## OFFICE OF NEW REACTORS

### RESPONSE TO OKLO, INC. CONCERNS

#### REGARDING INFORMATION CONTAINED IN DRAFT NRC REPORTS

**Figure 2. Fuel Element Presented in INL/EXT-17-43212**

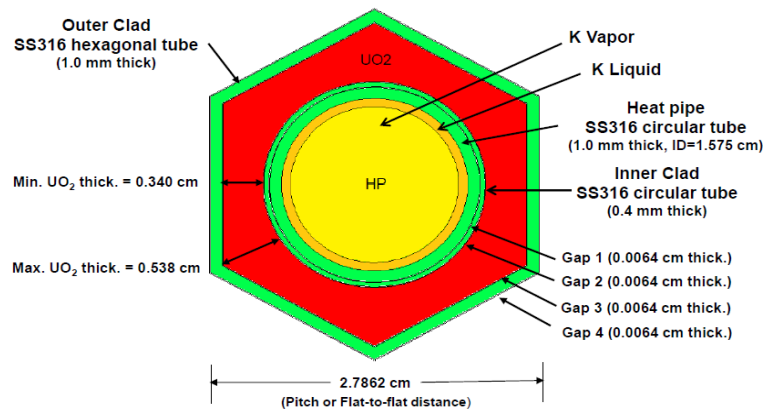
1. *Oklo-Identified Issue #3:* Paragraph 4, page 148 reads as follows:

The OKLO fuel cell is designed as an annular fuel region, with a cylindrical core representing the heat pipe. This geometry would require a new fuel component (modification to existing fuel component) since the effective coolant channel is now internal to the fuel cell and the fuel region is not cylindrical and may be interspersed with a sodium bond. The duct surrounding the fuel cell and the heat pipe walls would also need to be represented by a new (or by a modified) COR component.

*Oklo-Provided Suggestion:* Rewrite the paragraph as follows, “The Oklo fuel element geometry would require a new fuel component (modification to existing fuel component) since the effective coolant channels are not similar to the MELCOR code geometry and the fuel region is not cylindrical and may be interspersed with a sodium bond. The structures around the fuel region would also need to be represented by a new (or by a modified) COR component.”

*Oklo Reasoning:* This paragraph contains proprietary information and ECI, such as detailed information about Oklo’s fuel design.

The NRC does not agree that the information in this paragraph is proprietary. Information on Oklo’s use of heat pipes as its heat transfer mechanism is in the public domain and included in documents such as page 40 of the public version of Oklo’s DG-1353 Pilot Report.

The concept of using heat pipes surrounded by the fuel for reactor designs is also in the public domain and included in documents such as INL/EXT-17-43212, “Preliminary Assessment of Two Alternative Core Design Concepts for the Special Purpose Reactor,” issued May 2018 by Idaho National Laboratory (<https://www.osti.gov/servlets/purl/1413987>). Page 34 of this document, reproduced below in Figure 2, shows a core design with individual heat pipes surrounded by an annular hexagonal-shaped fuel element. This design also suggests thermally bonding gaps using liquid metal potassium or sodium. The paragraph that Oklo cites above is general enough that it could also describe the “Special Purpose Reactor” in the Idaho National Laboratory report.

The NRC staff does not consider general descriptions of Oklo’s use of heat pipes and fuel design geometry to be trade secret or confidential or privileged commercial or financial information that should be withheld from public disclosure. Consistent with the guidance provided in LIC-204, the NRC staff has determined that references to Oklo’s use of heat pipes and general geometric fuel design information as it relates to Oklo’s design are not proprietary information and should not be withheld from public disclosure. However, the NRC staff will consider Oklo’s suggested revision in the final version of the report.

**Figure 3. Replication of Figure B-23, “MELCOR Heat Pipe Temperature for a Transient-equilibrium Test Problem”**

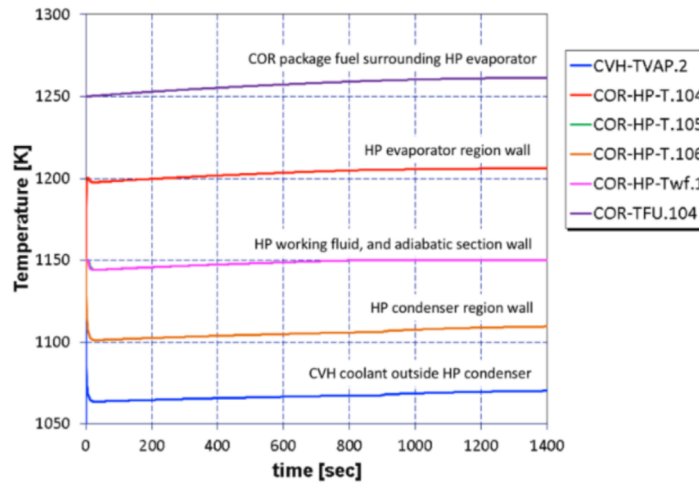
4. *Oklo-Identified Issue #6:* Figure B-23, page 150, is replicated below (Figure 3):

*Oklo-Provided Suggestion:* Delete this figure.

*Oklo Reasoning:* This figure discloses detailed fuel design information that Oklo usually considers proprietary information and ECI. Additionally, the removal of this figure from the report does not take away from the message conveyed in this report.

The NRC staff does not agree that the referenced MELCOR heat pipe temperature figure contains Oklo’s proprietary information.

The information in this figure does not represent data specific to the Oklo design. The information displayed is theoretical and was developed to test the accuracy of the general MELCOR heat pipe model. The NRC staff does not consider general descriptions of heat pipe performance be trade secret or confidential or privileged commercial or financial information that should be withheld from public disclosure. Consistent with the guidance provided in LIC-204, the NRC staff has determined that information contained in Figure B-23 (Figure 3 above) of “NRC Non-Light Water Reactor (Non-LWR) Vision and Strategy Volume 3: Computer Code Development Plans for Severe Accident Progression, Source Term, and Consequence Analysis,” is not proprietary and should not be withheld from public disclosure. However, the NRC staff will consider whether it is appropriate to clarify the nature of the information presented in this figure in the final version of the report.
